Recall Bulletin

PRODUCT EMISSION RECALL

SUBJECT: Oxygen Sensor Fracture

MODELS: 2011-2013 Chevrolet Express
2011-2013 GMC Savana
Cutaway Equipped with Gasoline Engine

(A) First Design Heated Oxygen Sensor (B) Second Design Heated Oxygen Sensor (1) Location of Part Number

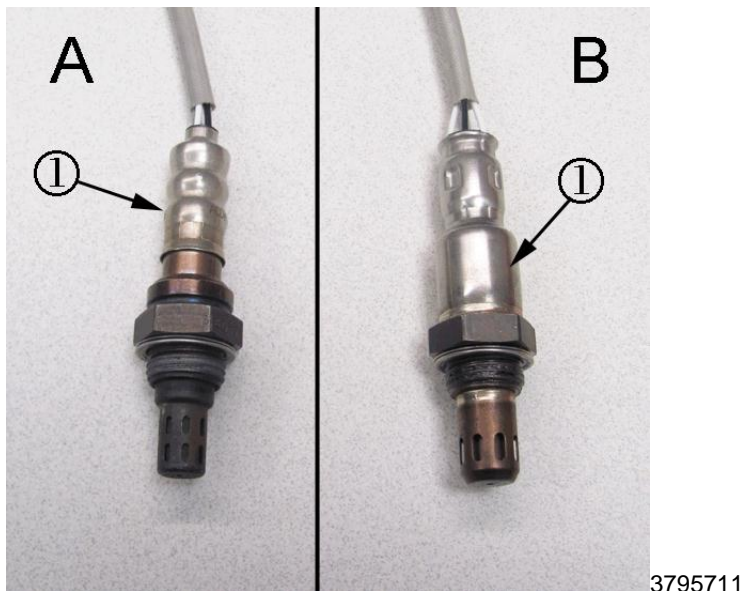
General Motors has decided to conduct a Voluntary Emission Recall involving **certain** 2011-2013 Chevrolet Express and GMC Savana cutaway vehicles equipped with a gasoline engine. The Oxygen (O₂) Sensor may fracture if condensation from the catalytic converter enters the O₂ sensor and causes a sudden temperature change. If this occurs, the Malfunction Indicator Lamp will illuminate.

3. Determine if a first design (A) or second design (B) heated oxygen sensor is installed using a light and mirror.
 - If a second design (B), P/N 12637297, heated oxygen sensor is installed, no further action is required. Lower the vehicle. Refer to *Lifting and Jacking the Vehicle* in SI.
 - If a first design (A), P/N 12656071 or P/N 12612571, heated oxygen sensor is installed, remove the sensor and replace it with a second design heated oxygen sensor. Refer to *Heated Oxygen Sensor Replacement – Bank 2 Sensor 1* in SI and *Heated Oxygen Sensor Replacement – Bank 2 Sensor 2* in SI.

Dealers are to inspect and, if necessary, replace both Bank 2 O₂ sensors and reprogram the Engine Control Module.

| Part Number | Description | Quantity/Vehicle |
|-------------|-----------------|------------------|
| 12637297 | SENSOR, HTD OXY | 2 |
